Appendix 2.2: Proposed Scope of SEI 2

Energy Isles Wind Farm-Proposed Supplementary Environmental Information Consultation

Energy Isles Wind Farm

Figure 1
SEI layout
(showing turbines to be removed for SEI 2)

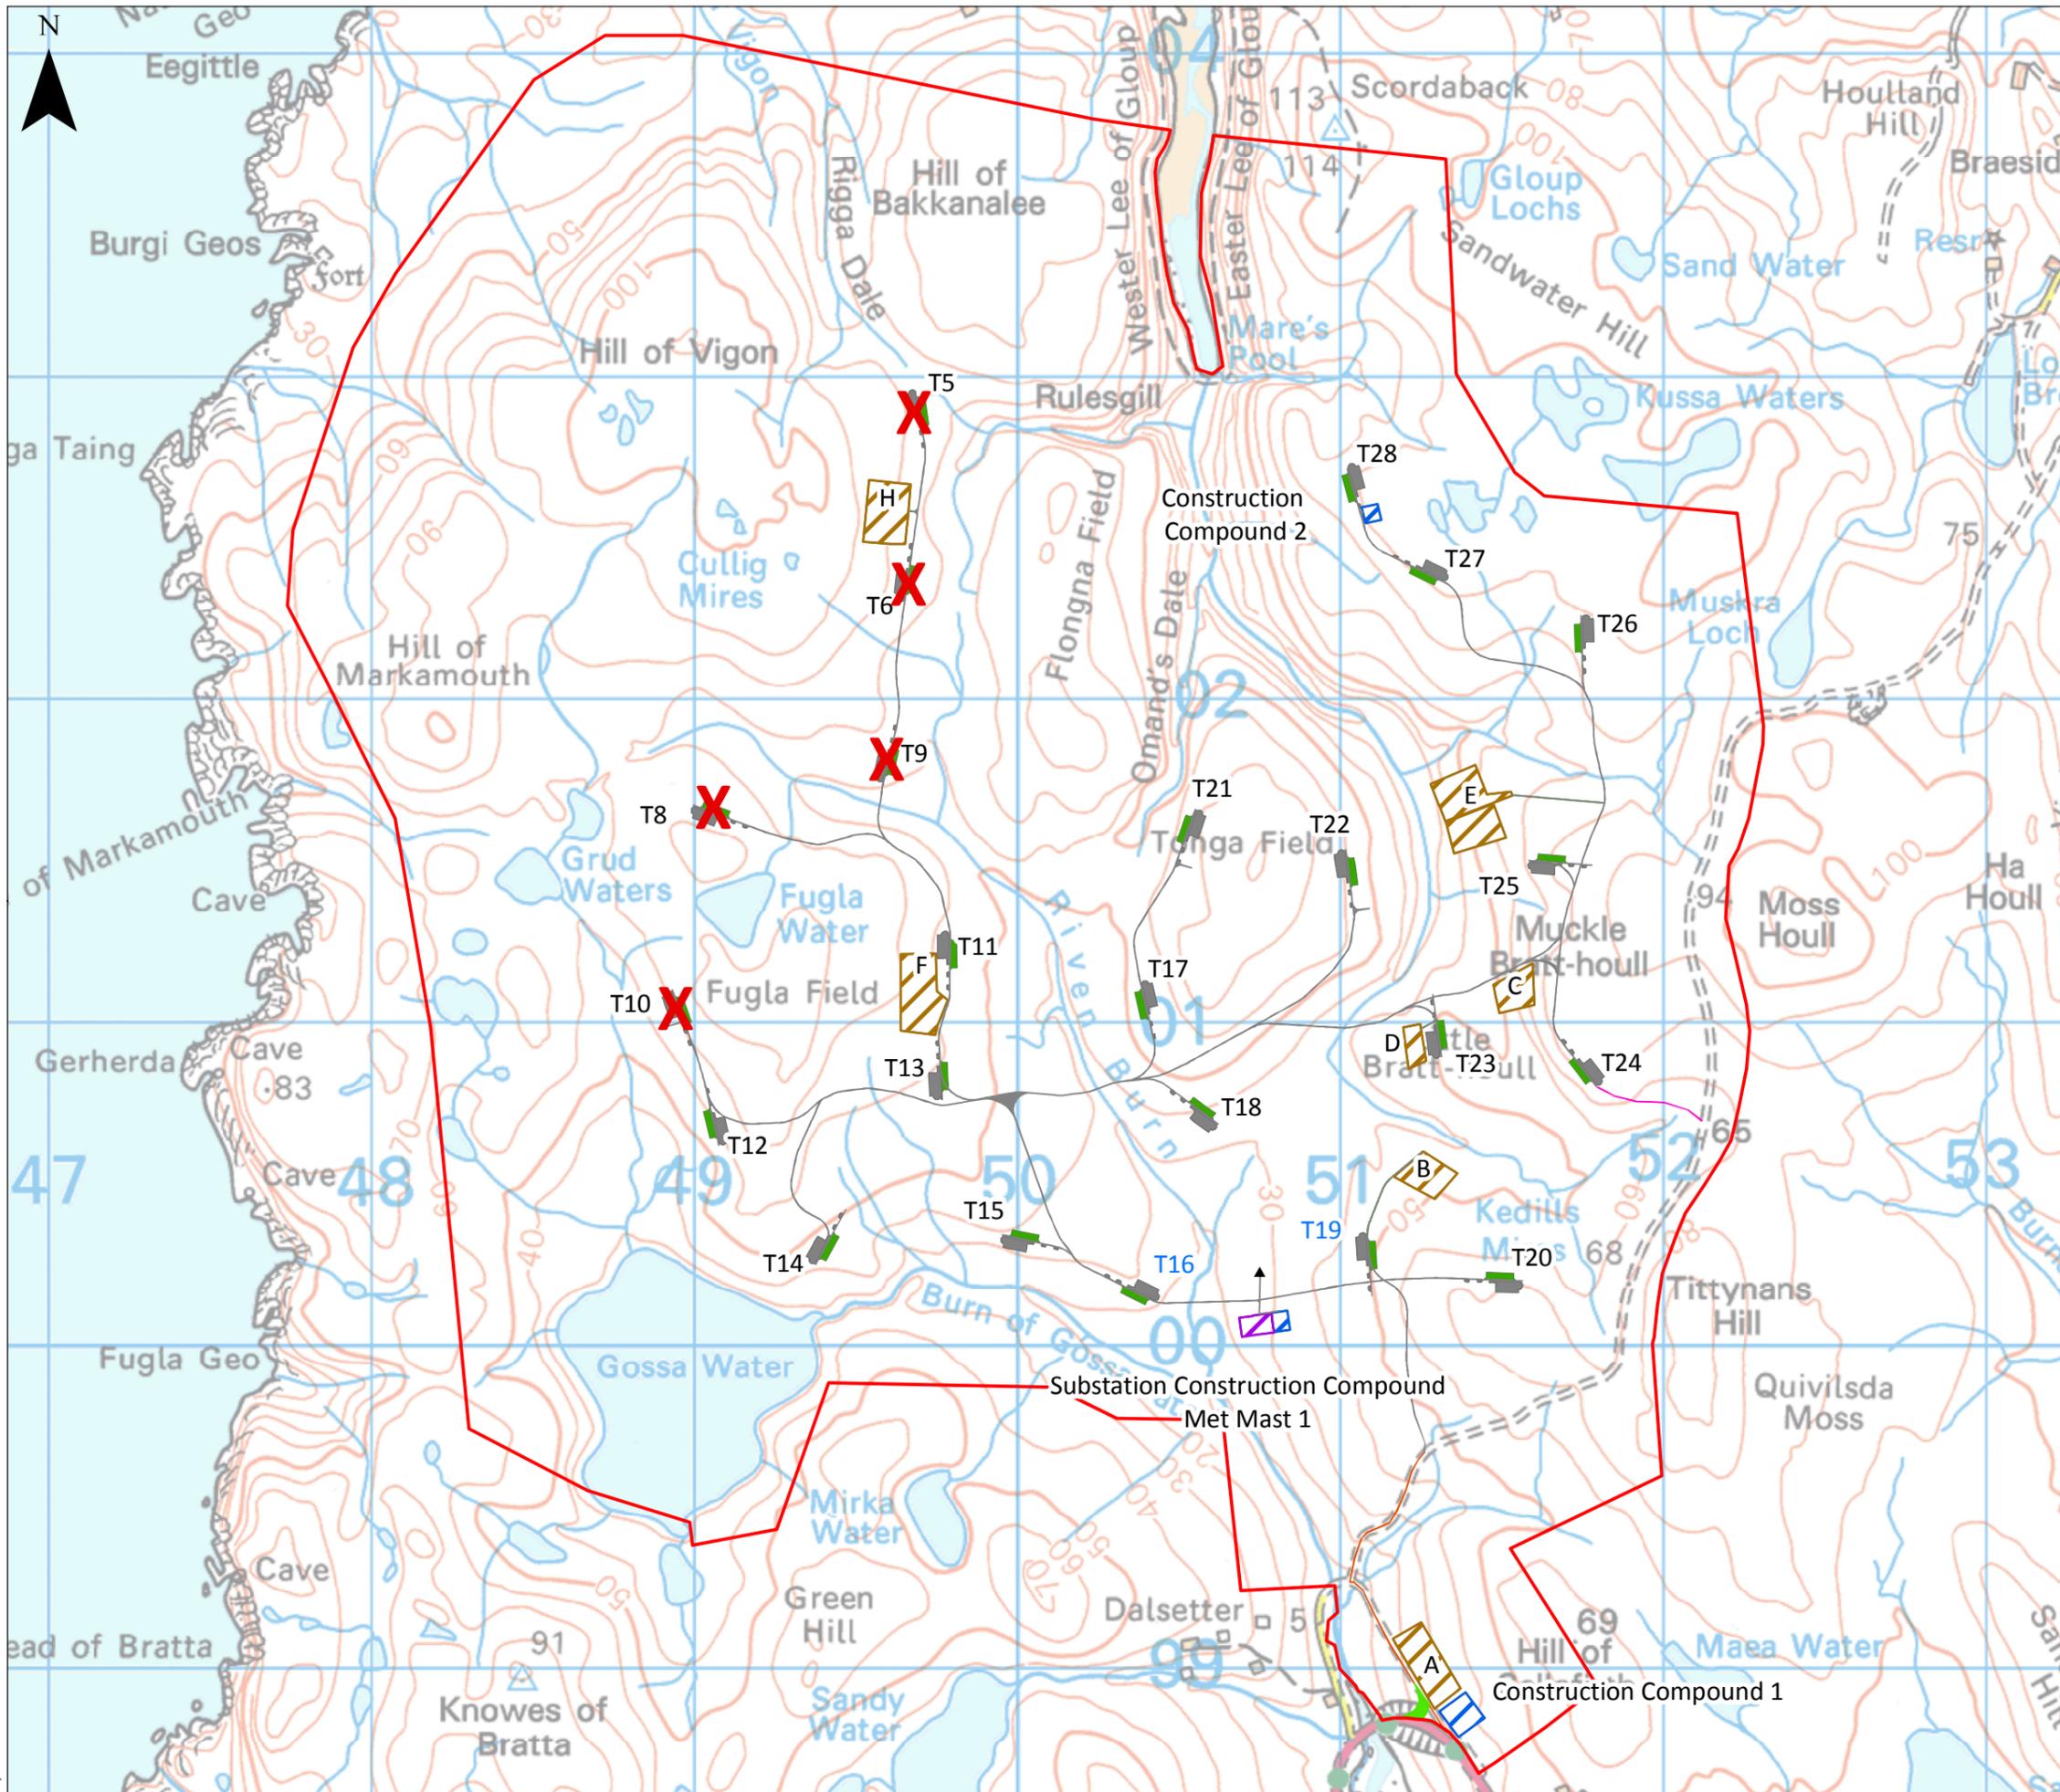
- The removal of turbines T5, T6, T8, T9 and T10 with all remaining turbines set at 180m tip height
- The removal of associated tracks and hardstandings; and,
- The removal of borrow pit H.

The enclosed Figure 1 highlights the turbines that are being omitted from the design that was submitted with the SEI in August 2020.
